METROPOLITAN GOVERNMENT OF NASHVILLE AND DAVIDSON COUNTY

Metropolitan Historic Zoning Commission
Sunnyside in Sevier Park
3000 Granny White Pike
Nashville, Tennessee 37204
Telephone: (615) 862-7970
Fax: (615) 862-7974

STAFF RECOMMENDATION
1509 Gartland Avenue
October 19, 2016

Application: New construction—addition
District: Lockeland Springs-East End Neighborhood Conservation Zoning Overlay
Council District: 06
Map and Parcel Number: 08309031400
Applicant: Jonathan Jones
Project Lead: Melissa Baldock, melissa.baldock@nashville.gov

MAIN FLOOR LAYOUT

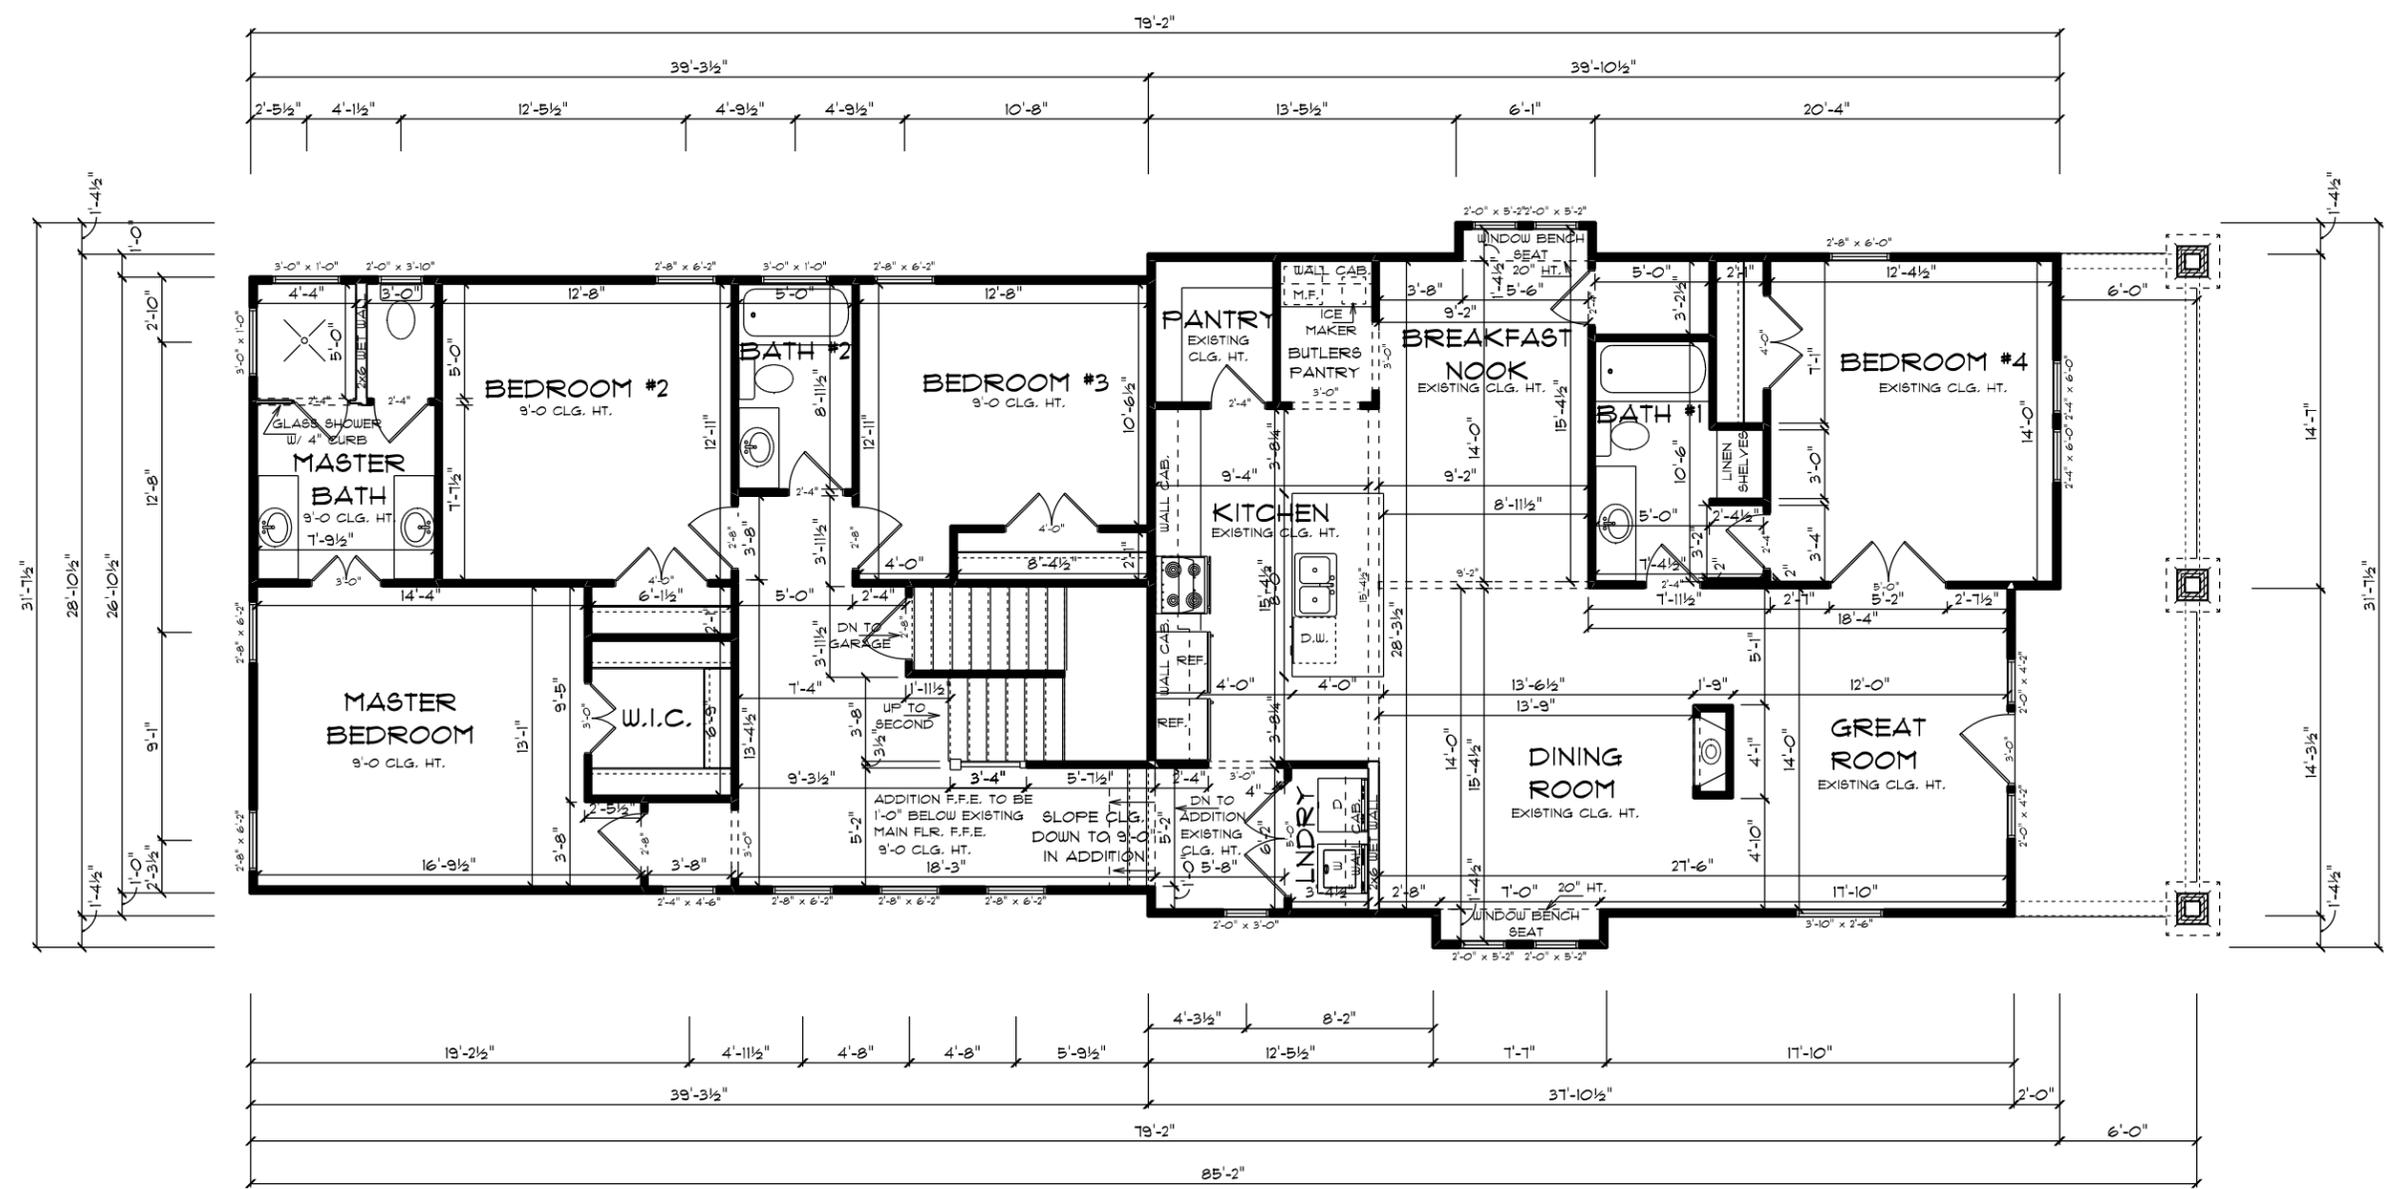
The addition will be inset one foot (1') from each of the back corners of the house. Because the addition has three levels – a basement garage, a main floor, and a finished attic space with dormers, staff finds that a two foot (2') inset would be more appropriate. The addition will match the depth of the historic house at thirty-nine feet, four inches (39'4"). The addition will add approximately one thousand and fifty-six square feet (1,056 sq. ft.) of footprint to the historic house, which has a footprint of approximately one thousand, one hundred and sixty square feet (1,160 sq. ft.), not including the front porch.

Location & Removability: The location of the addition at the rear of the existing building is in accordance with the design guidelines. Staff recommends a larger inset of two feet (2') at the back in order to keep the addition in scale. With this change, the addition will be designed so that if it were to be removed in the future, the historic character of the house would still be intact. With the increase of the inset from one foot to two feet (1' to 2'), staff finds that the addition meets Section II.B.10.a and d. of the design guidelines.

1. The addition be inset two feet (2') at the rear of the historic house;
2. The siding reveal either match that of the historic wood siding or have a maximum reveal of five inches (5");
3. The basement level of the addition be clad in a foundation material like a split face concrete block rather than clad in siding;
4. Any concrete block be split-face;
5. Staff approve the final details, dimensions and materials of windows and doors prior to purchase and installation;
6. Staff approve the roof shingle color, dimensions, and texture; and
7. The HVAC shall be located behind the house or on either side, beyond the midpoint of the house.

LEFT ELEVATION

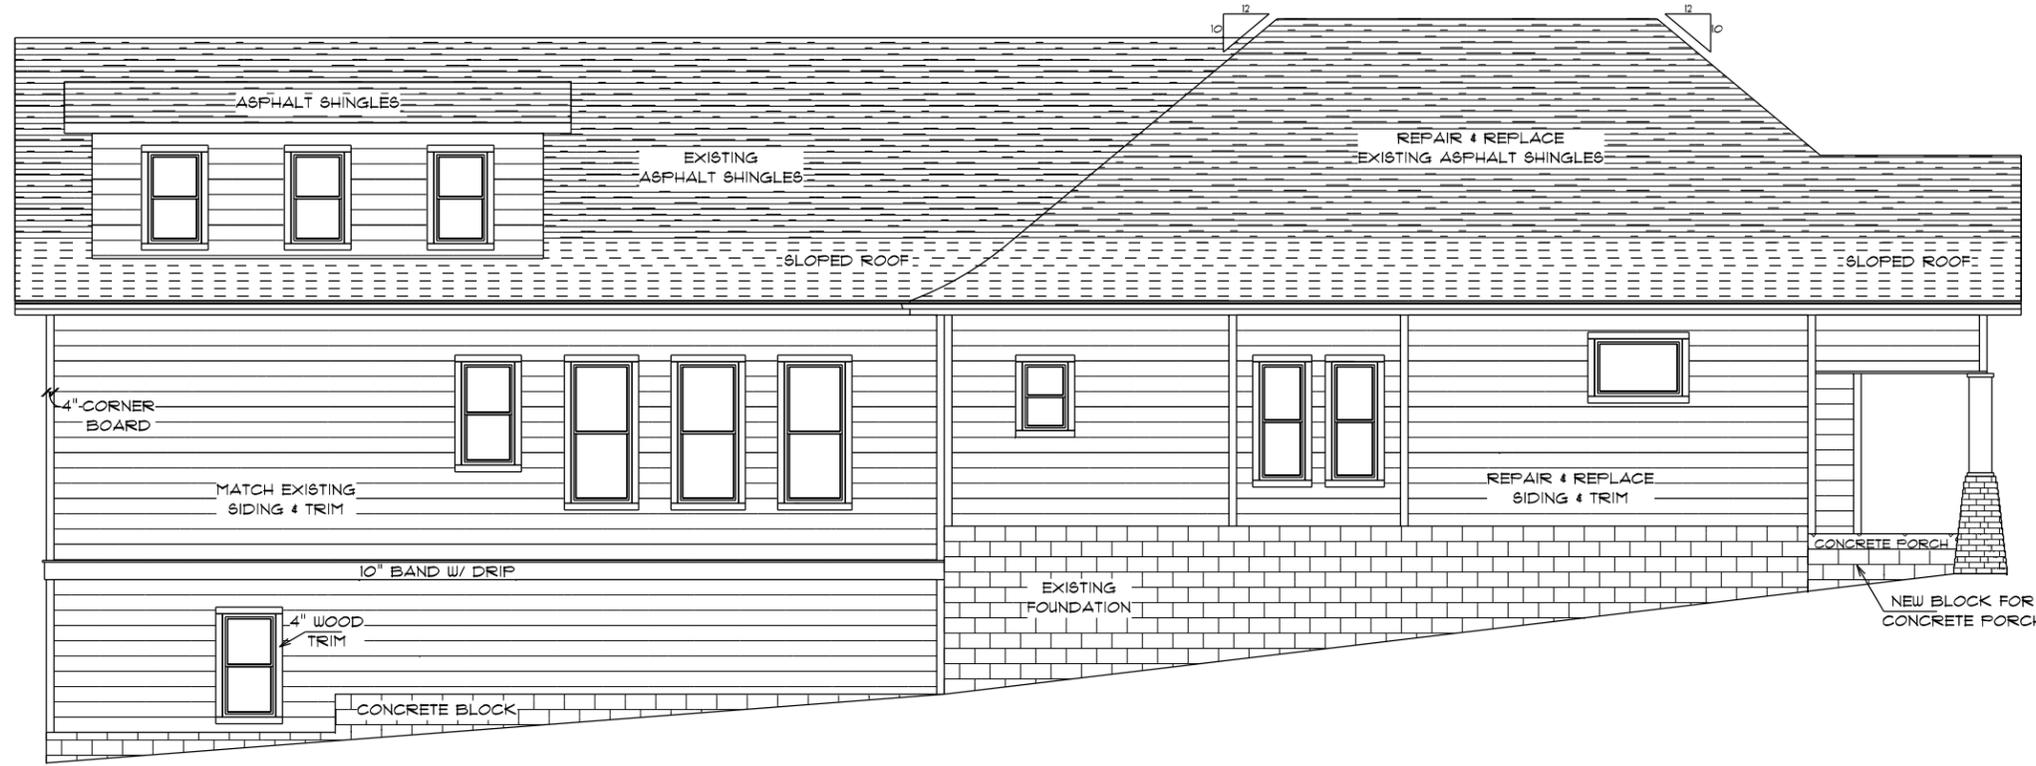
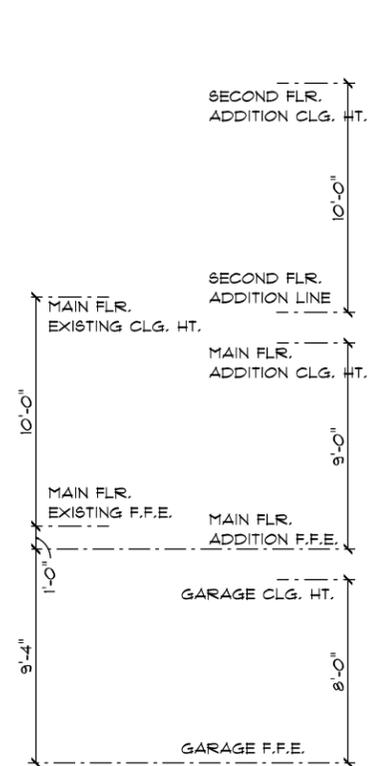
*The applicant intends to carry the siding down to the basement level. Staff finds that this increases the perceived height of the addition and does not follow the historic context. Staff recommends that the applicant keep the foundation material exposed at the basement level, as is typical of historic houses with tall foundations due to the slope of a site. Staff also recommends that the concrete block be split-face.

^The drawings indicate that the siding on the addition will match the “existing siding and trim.” Staff recommends that the siding match the historic siding reveal underneath the vinyl siding or have a maximum reveal of five inches (5”).

With the use of split-face concrete block (or another approved foundation material) at the basement level, the siding reveal matching the historic wood siding or being a maximum of five inches (5”), and staff’s final approval of the windows, doors, and roof color, staff finds that the proposed materials meet Sections II.B.4. and II.B.10. of the design guidelines.
